June 10, 2025

COMMITTEE TO BRIDGE THE GAP COMMENTS ON NASA'S *FINAL¹ PHASE 1 GROUNDWATER CORRECTIVE MEASURES STUDY & DTSC'S DRAFT NASA GROUNDWATER PHASE 1 STATEMENT OF BASIS* FOR THE SANTA SUSANA FIELD LAB

Duration of Active Treatment vs. Monitored Natural Attenuation at Each Well

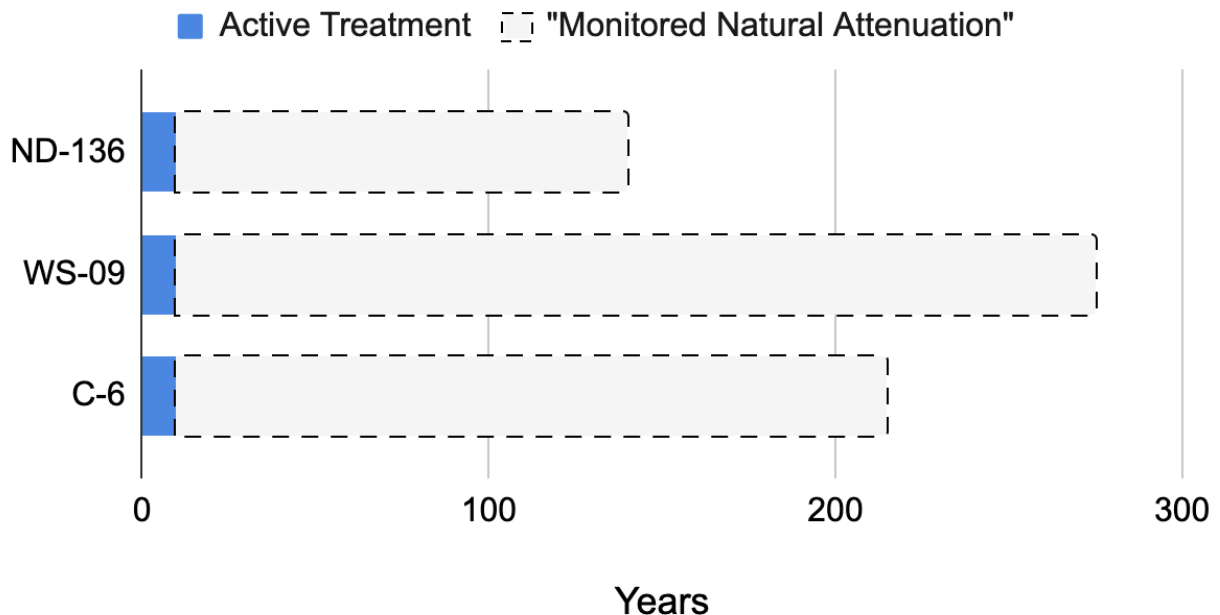
NASA predicts that the cleanup alternatives it is recommending for Phase 1 – a few years (~a decade) of active treatment to be followed by MNA (essentially walking away from any further cleanup) – will take 140 years, 275 years, and 215 years to achieve the TCE cleanup goal at wells ND-136, WS-09, and C-6, respectively.³⁶ NASA believes that even these absurd time estimates are optimistic, and that the actual remediation timeline could be much longer.³⁷
